BULLETIN NO. 33

JEFFERSON LAB

TECHNICAL ENGINEERING & DEVELOPMENT FACILITY
(TEDF TWO)

Bulletin No.33
Project No. 20080400
March 04, 2011

1 SECTION DETAIL
3" = 1'-0"

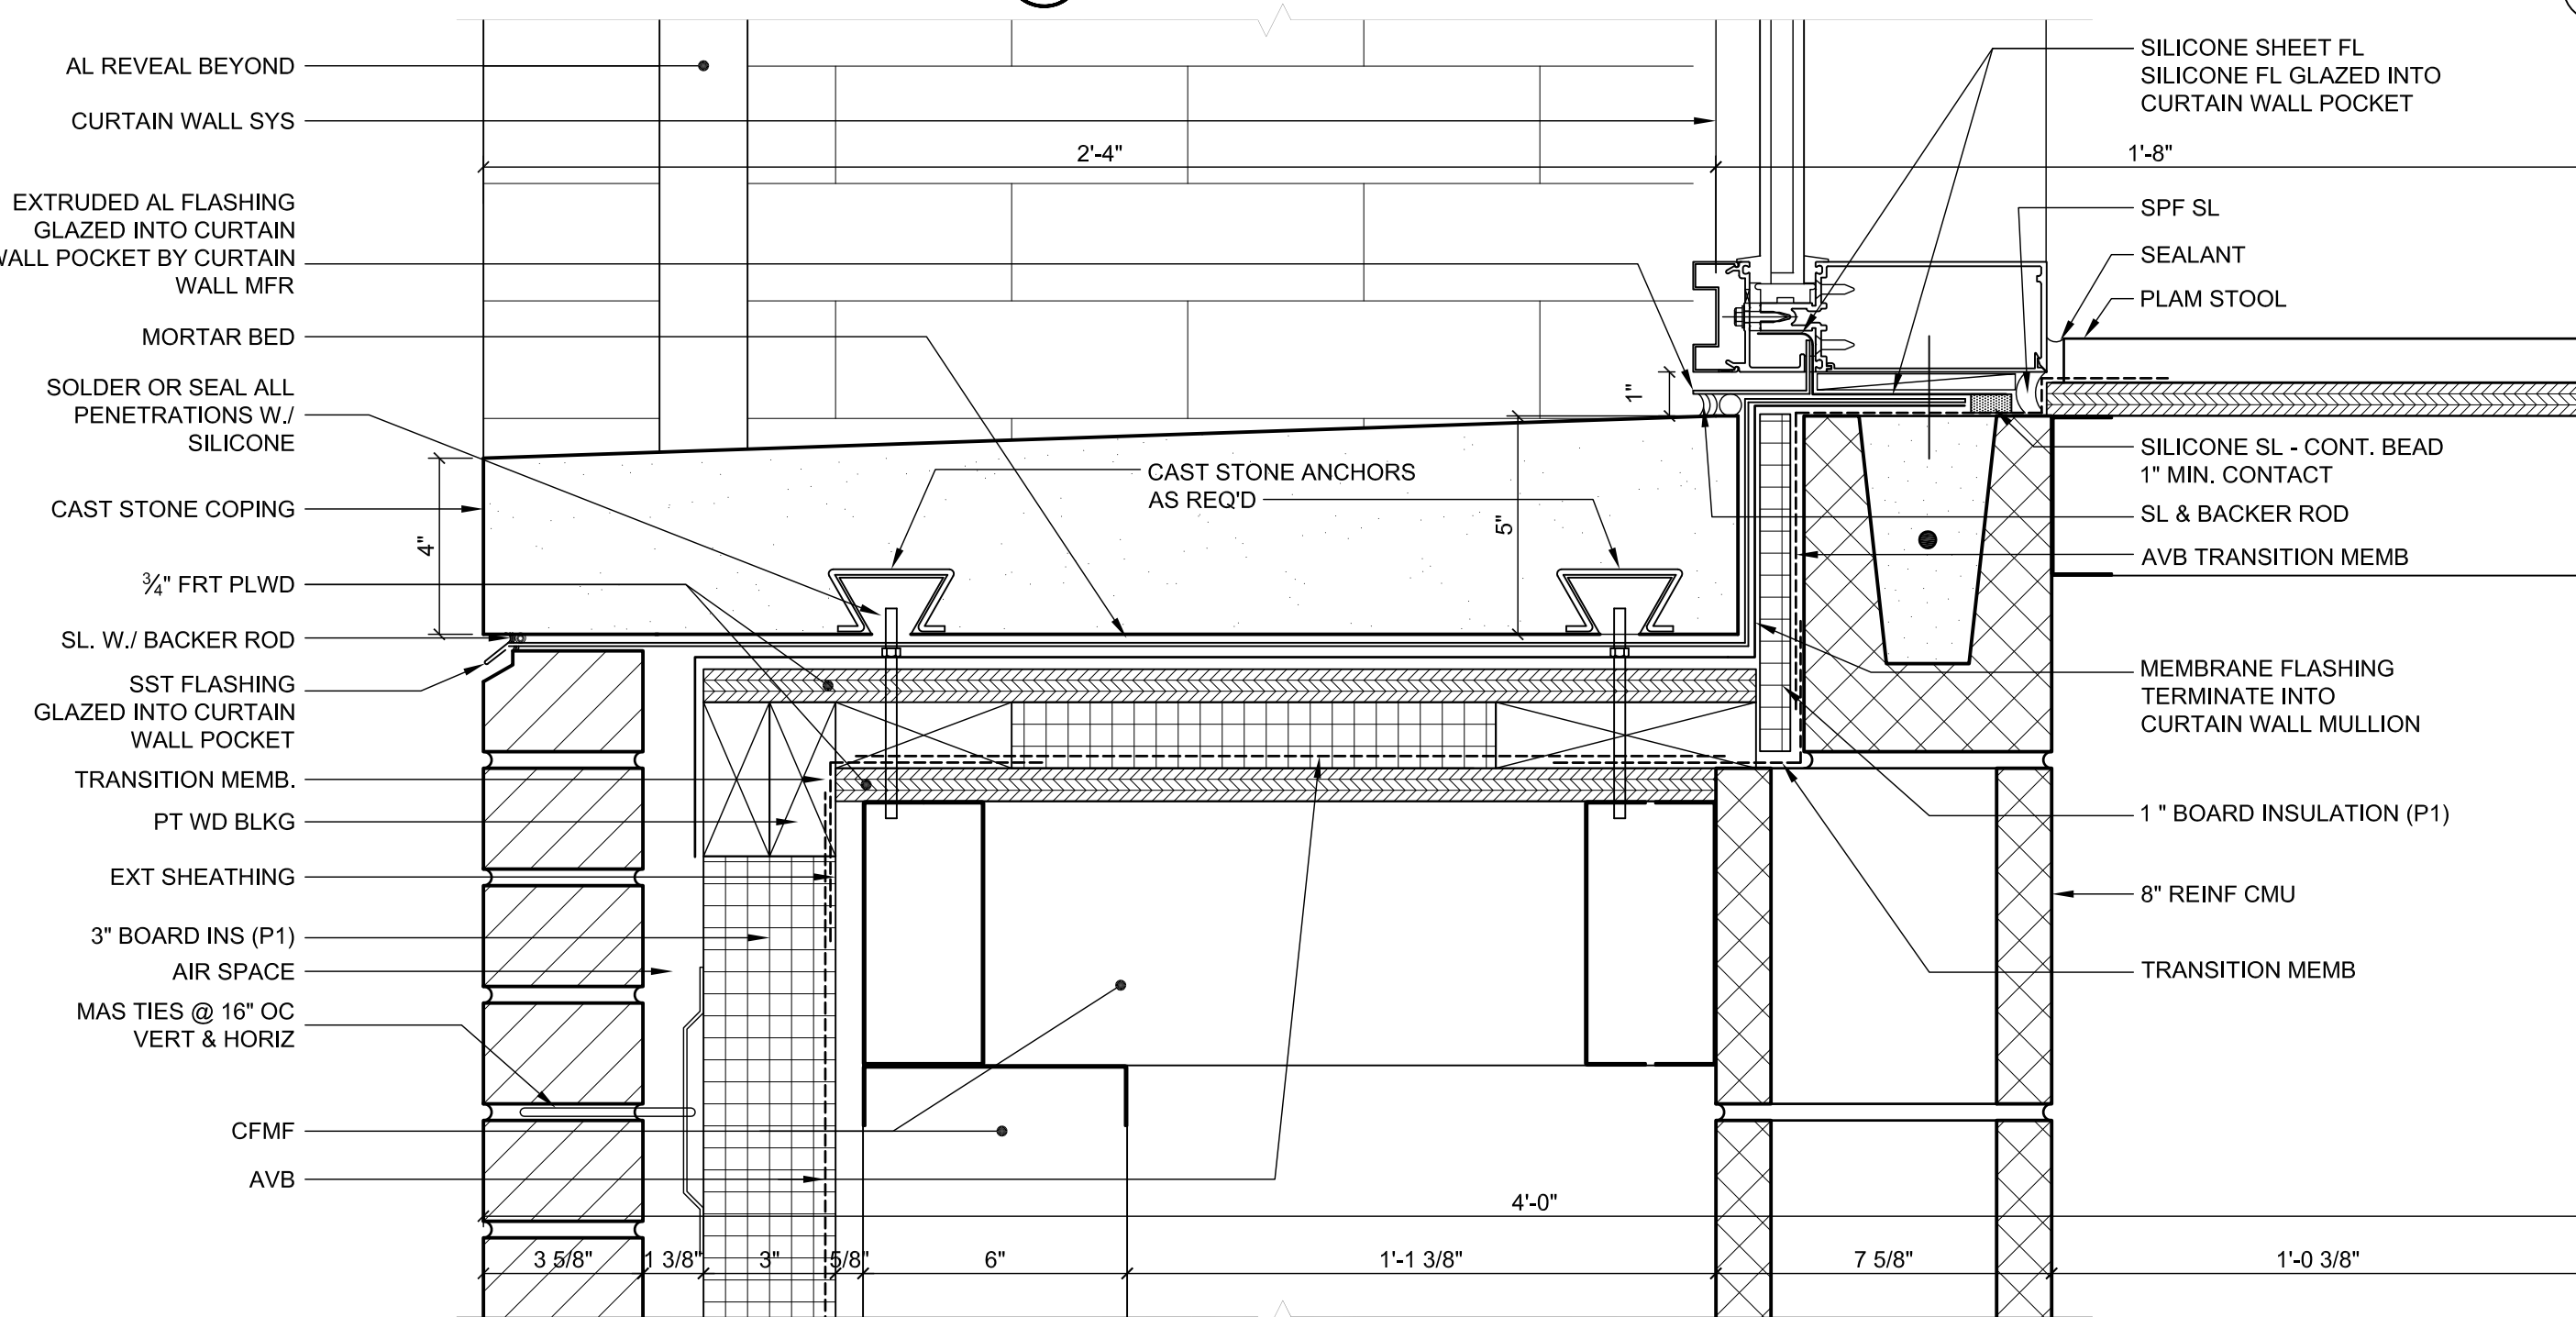
1. Revised section details

SCALE	DRAWING NUMBER	SHEET	REV
3" = 1'-0"	100024-TS-A161-STE	TED-A3.2.4.2	-

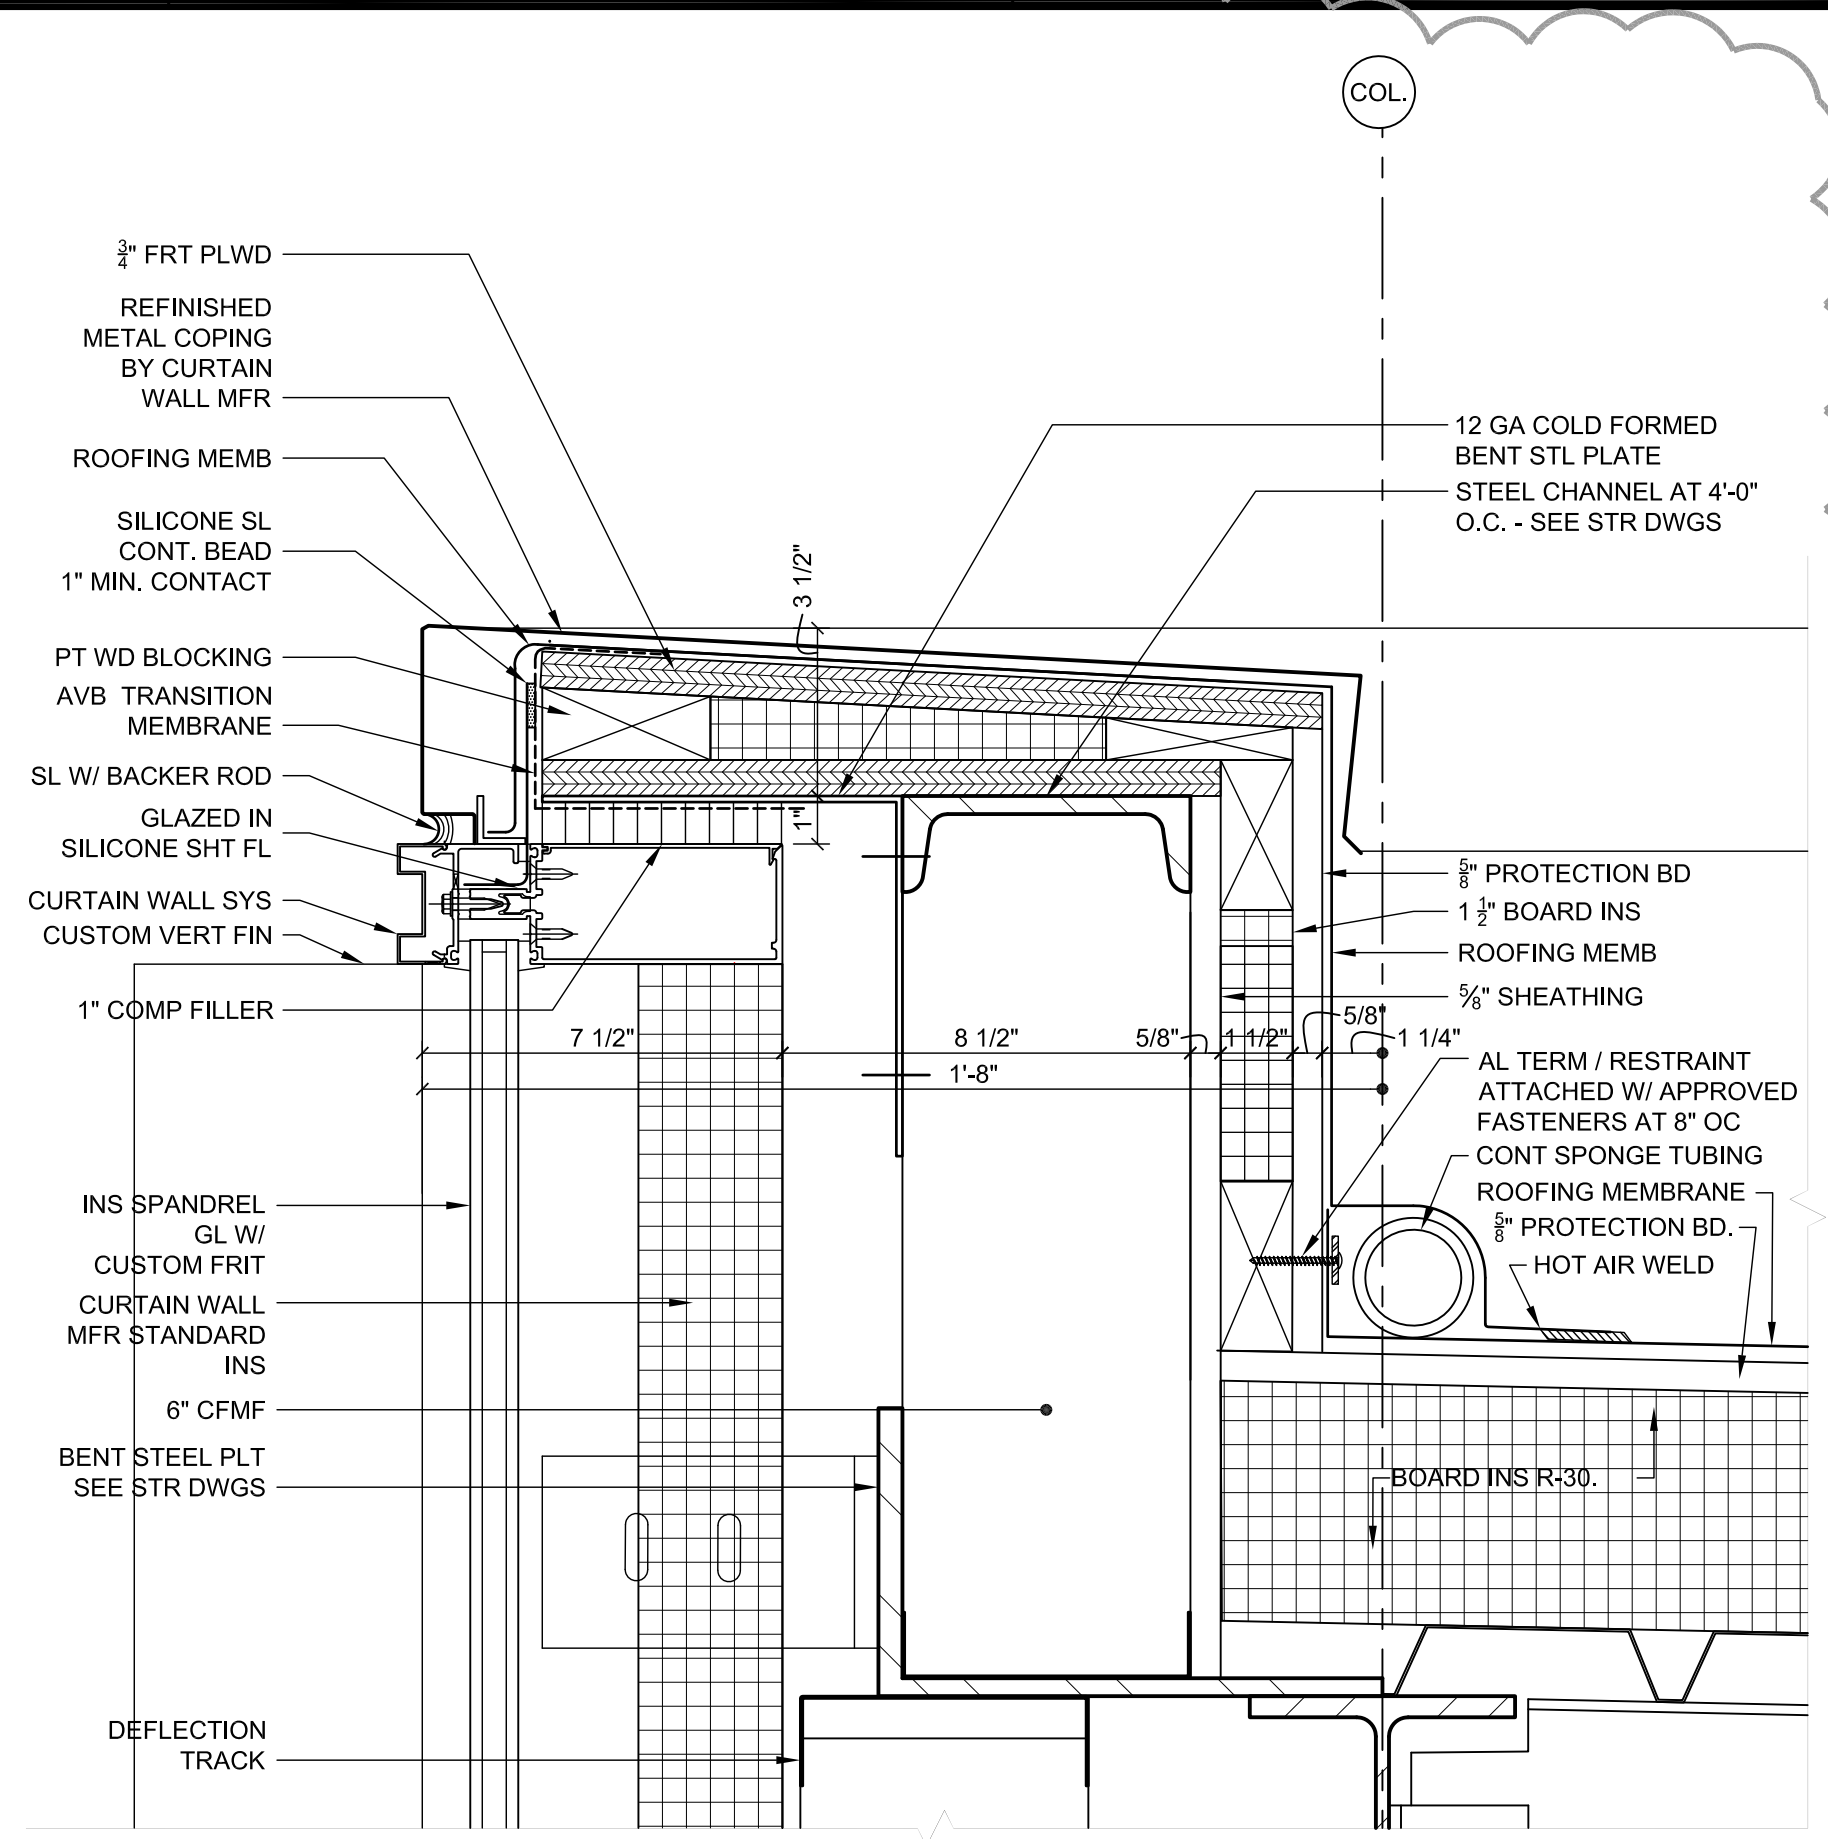
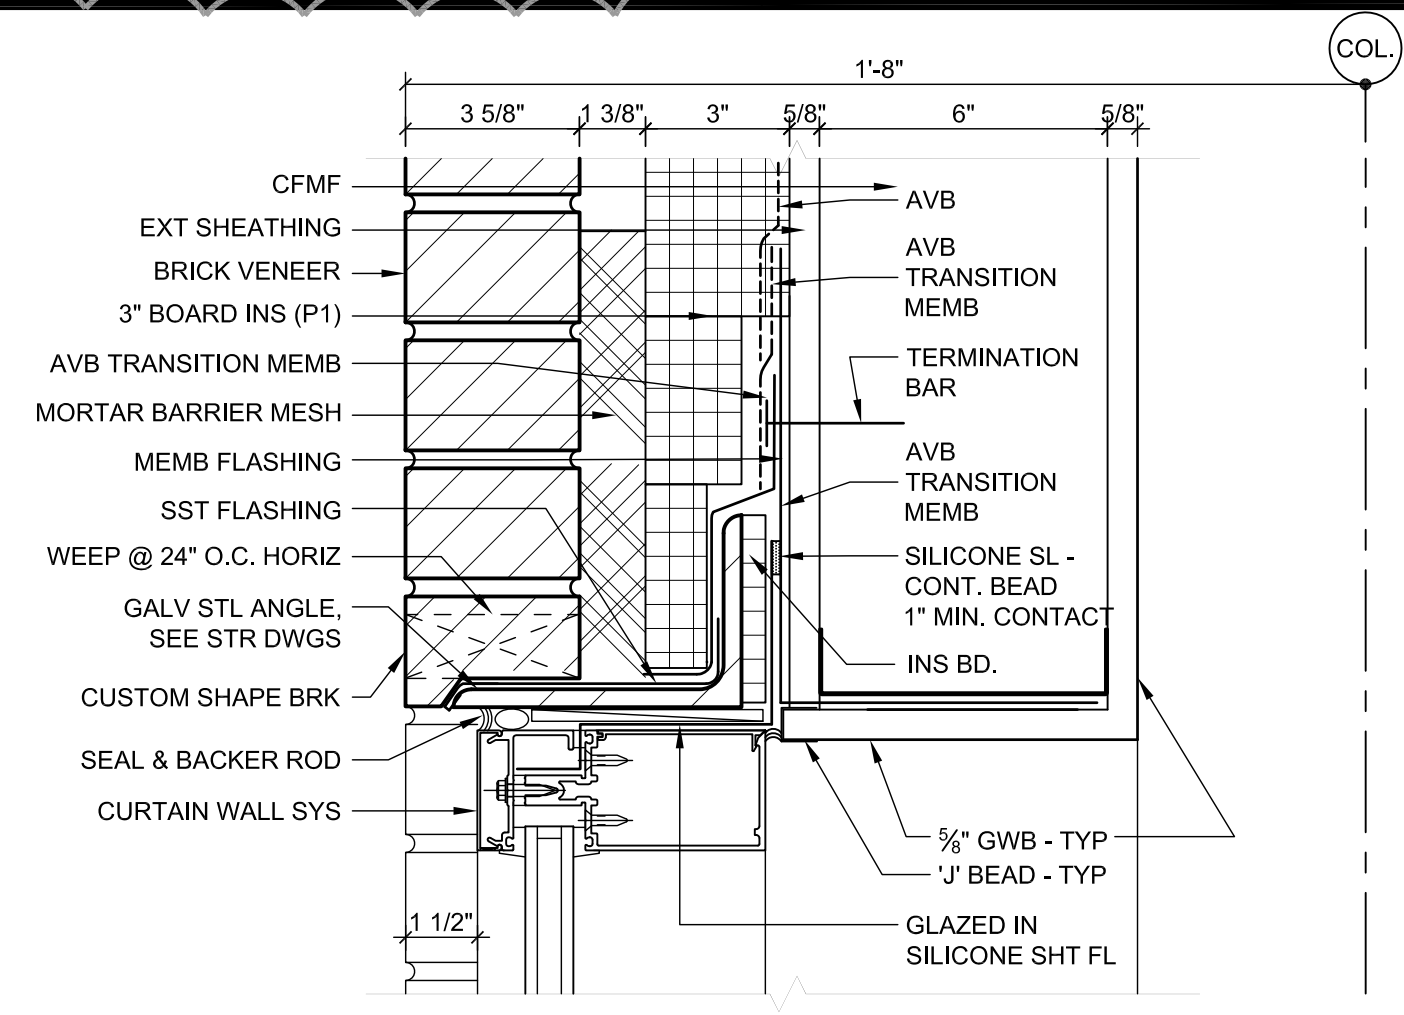
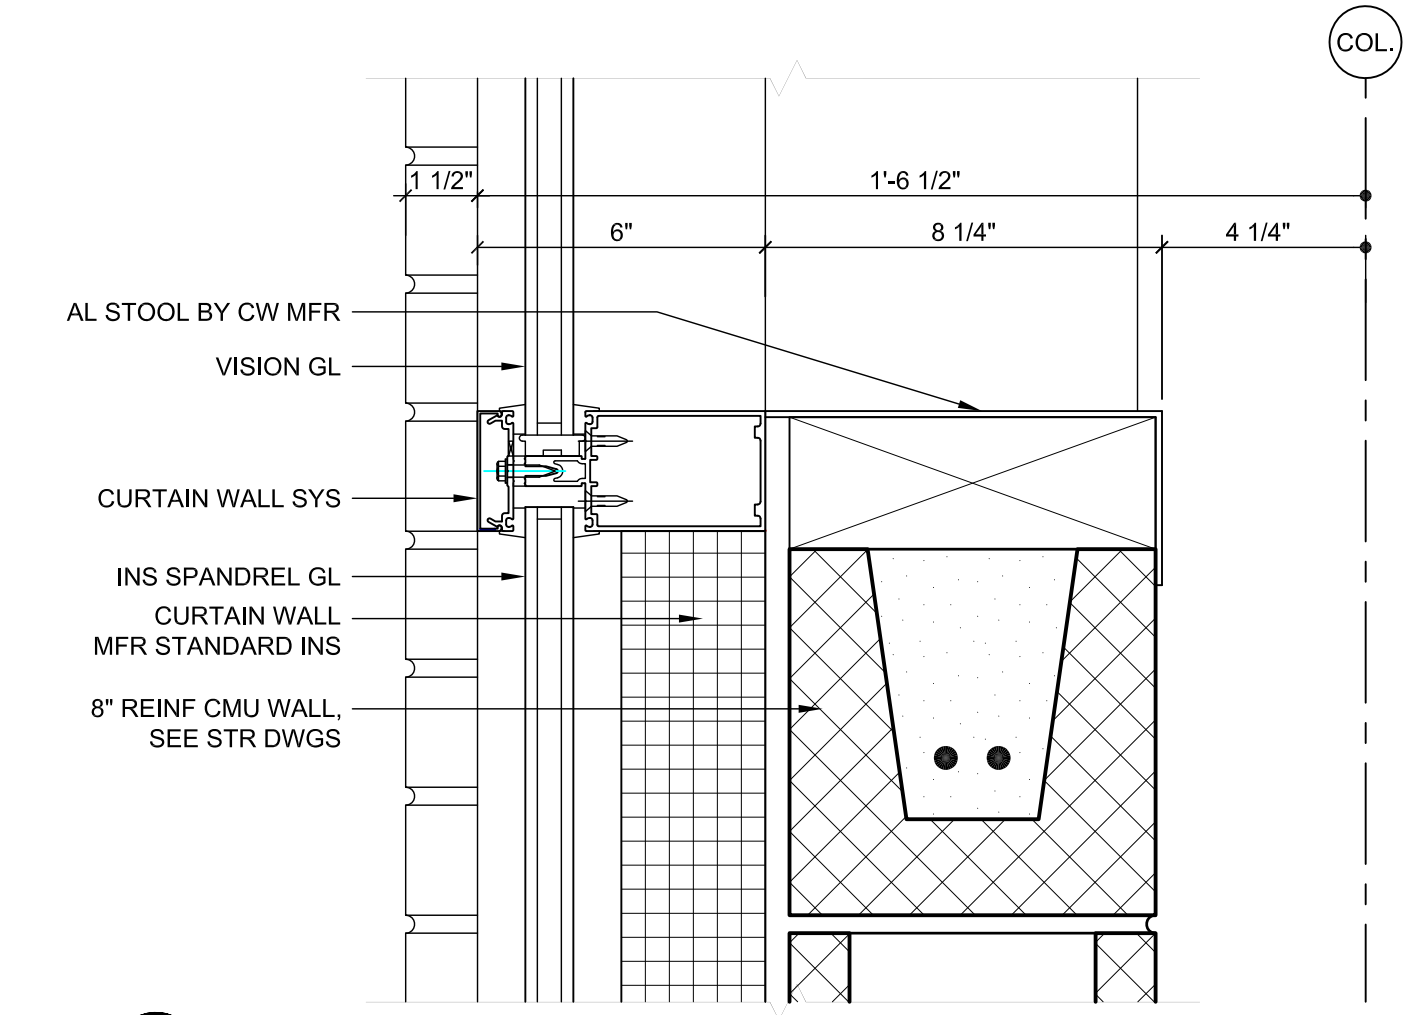
1. Revised section details
